Green Hill Solar Farm

Hydraulic Modelling Technical Note

BESS

Document Reference: EX5/GH8.2.2_A

Figure 5: Comparison of modelled 1% AEP +13%CC flood extent and EA recorded flood outlines

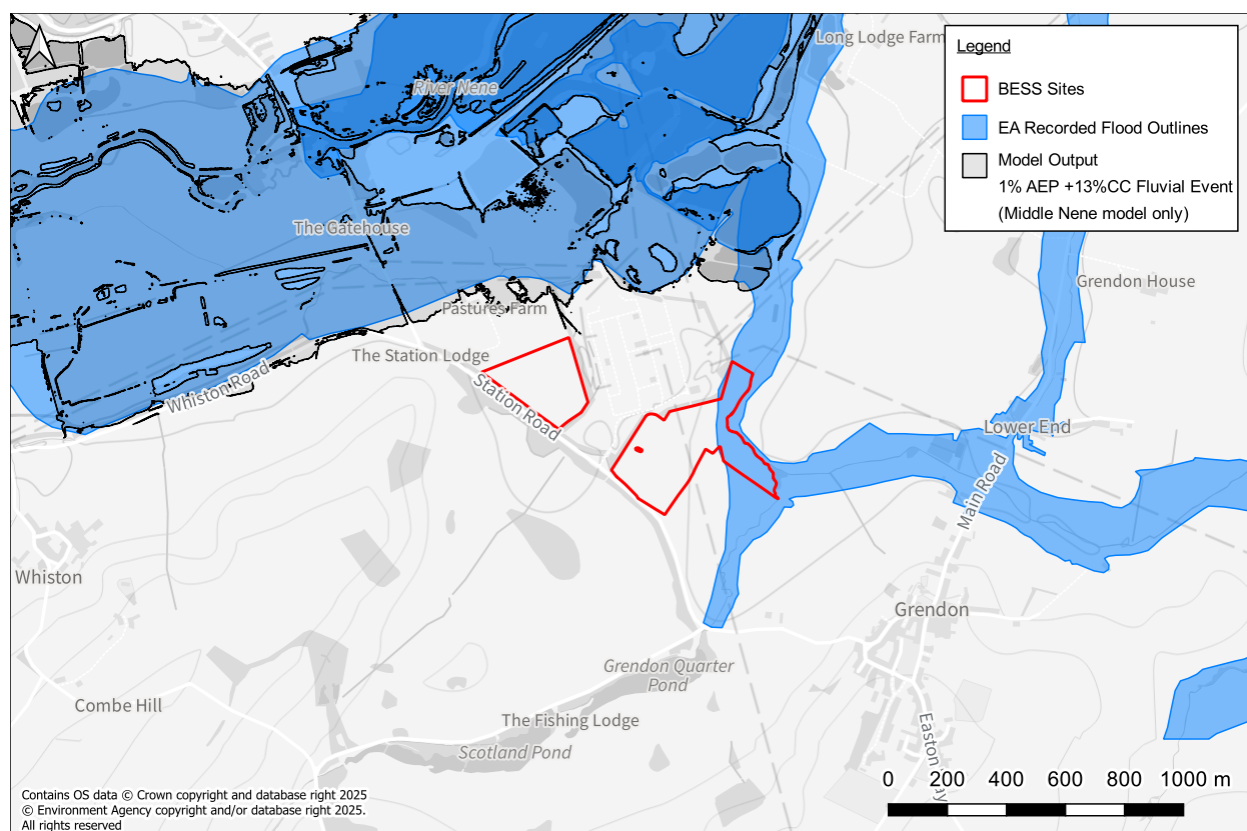
5	Please include a map within the model report/Flood Risk Assessment which compares model results to recorded flood outlines. Recorded flood outlines held by the Environment Agency can be downloaded from the Defra Data Services Platform (environment.data.gov.uk)	The Applicant notes the Environment Agency's comments. Comparison maps of model results with recorded flood outlines will be prepared and included in the Hydraulic Modelling Report appended to the ES Appendix 10.1 Flood Risk Assessment and Drainage Strategy Report [EX5/GH6.3.10.1_B] .	Figure 5

- 2.4.4 Comparison of the modelled 1% AEP +13%CC flood extent with the EA recorded flood outlines dataset shows very good agreement, providing confidence in the model outputs. The comparison is presented in Figure 5.

Figure 8: Comparison of modelled 1% AEP +13%CC flood extent and EA recorded flood outlines

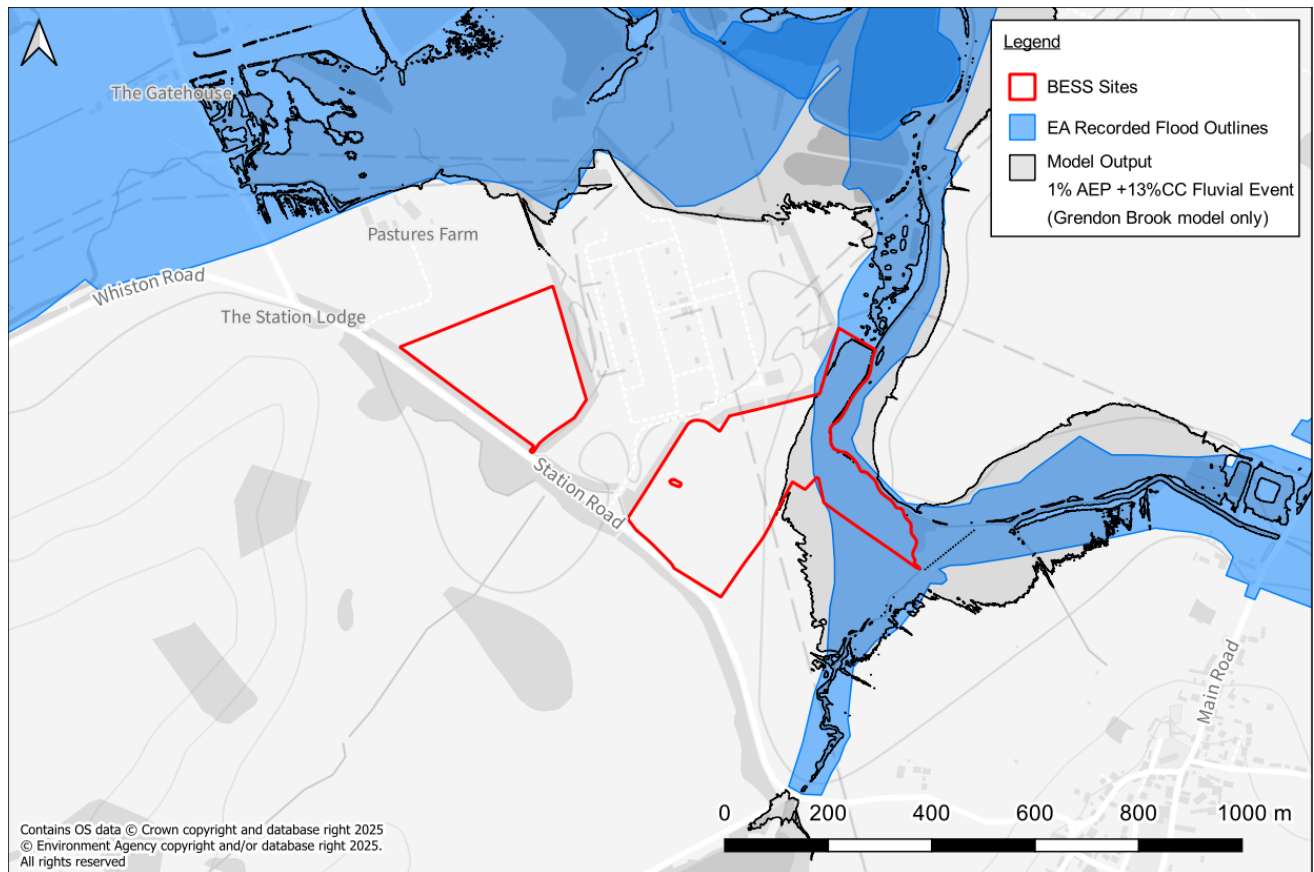
5	Please include a map within the model report/Flood Risk Assessment which compares model results to recorded flood outlines. Recorded flood outlines held by the Environment Agency can be downloaded from the Defra Data Services Platform (environment.data.gov.uk). Please see comment 15.3 within worksheet Model Performance within the attached spreadsheet.	The Applicant notes the Environment Agency's request. A comparison map of model outputs against recorded flood outlines (sourced from the Defra Data Services Platform) will be produced and included within the Hydraulic Modelling Report appended to the ES Appendix 10.1 Flood Risk Assessment and Drainage Strategy Report [EX5/GH6.3.10.1_B] .	3.4

- 3.4.4 Comparison of the modelled 1% AEP +13%CC flood extent with the EA recorded flood outlines dataset shows very good agreement, providing confidence in the model outputs. The comparison is presented in Figure 8.
